Counters Creek Flood Alleviation Scheme: Supplementary Information

1. Introduction

Figure 1: Screen shot of surface flooding risk map from EA website.

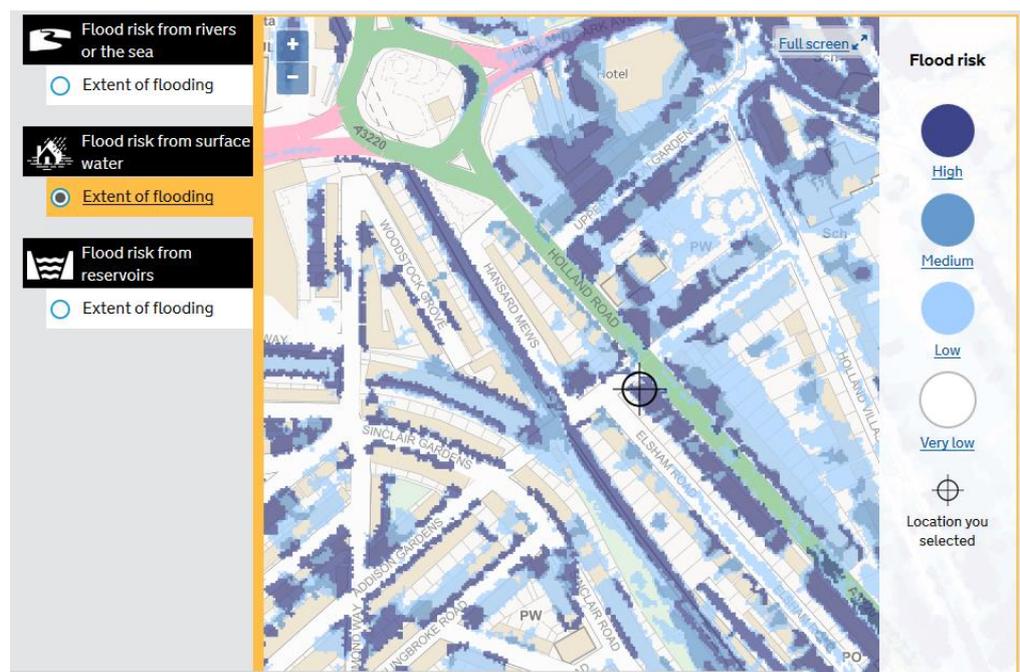
Modelling: your models for climate change assume that the rainfall falling in the area enters the sewer system. Shouldn't your models allow for scenarios where the sewers are surcharging and water cannot enter the sewer as they are full? Surface water drainage in RBKC is part of the sewer

system as it is combined so it is not clear why both systems seemed separated in your models (paragraph before last in your letter). Further details of the modelling used will be required to fully understand how the model works.

The hydraulic models used by Thames Water represent the sewer network only. They are conservative in that they make no allowance for the ability of surface water to get into the sewer network eg extent or availability of road gullies is not modelled (for all scenarios, not just climate change), so the water levels in the sewerage system will be predicted to be higher than perhaps would be observed under severe rainfall scenarios, where the surface drainage system capacity could restrict the amount of water entering the sewer network. Even under these extreme conditions, the surcharge water levels within the sewer network are not predicted to reach ground level and therefore there should not be any restriction to surface water entering the sewer system because of surcharged sewers. It is worth remembering that hydraulic sewer flooding problem is predominately observed in basement properties in this area caused by sewer surcharge and backing up of laterals as opposed to overland sewage escape. Thames Water believes it is likely that the effectiveness of the surface water collection system will be the challenge for climate change scenarios, where rainfall is more likely to be intensive, thus overwhelming the surface drainage system and as a result of not being able to get into the sewerage system and potentially cause flooding to properties through overland flooding.

As discussed at the meeting, the Environment Agency uses data provided by the LLFA to create two-dimensional models of the area to estimate the overland flooding risk (see figure 1 below, which is a screen-shot from the EA website showing part of the Counters Creek area). This model makes assumptions about how much surface water can drain into the sewer network, and from the topography of the area shows where surface water will accumulate. Coupling this model to the sewerage network model, in order to increase the accuracy of predictions, would be a lengthy and costly undertaking.
